Re: Woodfarm Commercial

POADP # 729

The City Staff Development Review Committee has reviewed Woodfarm Commercial Master Development Plan (M.D.P.) formerly (POADP) # 729. Please find enclosed a signed copy for your files. Your plan was accepted, however please note the following:

The City Staff Development Review Committee has reviewed Morton Southwest Commercial Subdivision Preliminary Overall Area Development Plan. Please note that your plan was not accepted, based on the following:

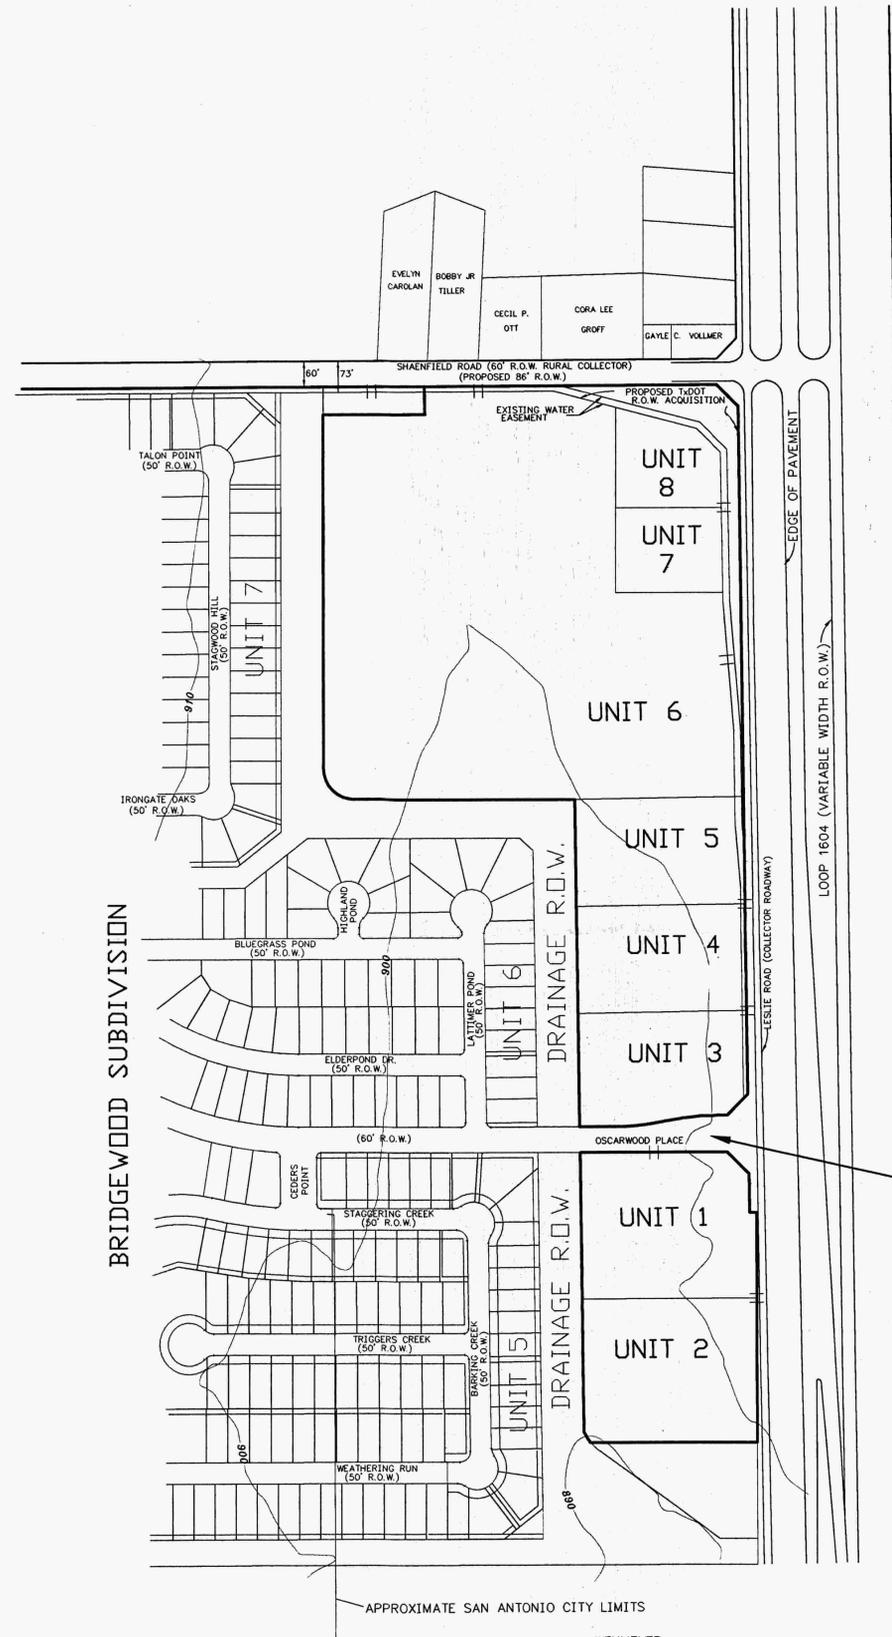
- The two proposed access point to Shaenfield Road is acceptable with the City of San Antonio. These access points shall have dedicated eastbound right turn deceleration lanes (100 feet of storage length and 60 feet of taper length). The access points shall accommodate two 12-foot outbound lanes (one left-turn and one channelized right-turn lane), and one 16-foot inbound lane. One access points shall be located a minimum of 500-feet form the intersection Loop 1604 FR and Shaenfield Road. The other access point along Shaenfield Road shall be space adequately in order to provide safe right-turn and left-turn movement from the other proposed driveway.

- The six proposed access points to Loop 1604 are acceptable with the City of San Antonio and will be the maximum number permitted. Until Loop 1604 is upgraded to a full freeway section, the 6 eligible access points must tie into Leslie Road. One of the access points is existing Oscar Wood Place (Local Type "B"). Location for the access points along Loop 1604 shall be determined and approved by TxDOT. The two northern most access point shall have a dedicated southbound right turn deceleration lane (100-feet of storage and 175-feet of storage length – the taper shall follow current TxDOT guidelines in the Roadway Design Manual). The access point at Oscar Wood Place, shall have a dedicated southbound right turn deceleration lane (175-feet of storage length and the taper shall follow current TxDOT guidelines in the Roadway Design Manual).

- All project driveways shall conform to the Uniform Development Code (Table 506-7 Minimum Driveway Throat Lengths).
- The Developer shall provide 43 feet of ROW from the centerline of Shaenfield Road adjacent to this proposed project. This will require a property dedication by the developer.

- Any access points proposed on Oscar Wood Place shall be a minimum of 400-feet from the future upgraded Loop 1604 Frontage Road. All access points shall have a minimum of 40-foot driveway storage length. The access points shall accommodate two 12-foot outbound lanes (one left-turn and one channelized right-turn lane), and on 16-foot inbound lane.

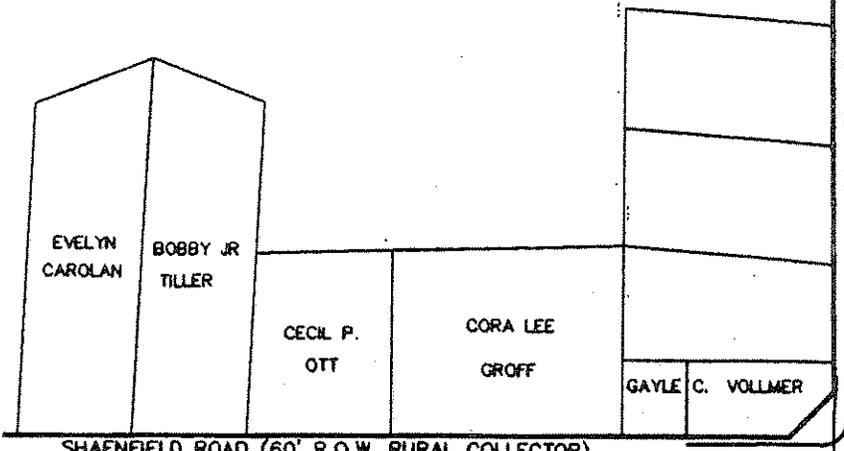
- Annotate Perimeter property lines
- Indicate any proposed POADPs adjacent to this property.
- Contour lines are missing.
- Show connectivity between proposed units.
- Annotate existing and proposed right-of-way widths on plan.
- Street names were not shown on plan
- Show existing zoning only.
- An approved T.I.A. will be required.
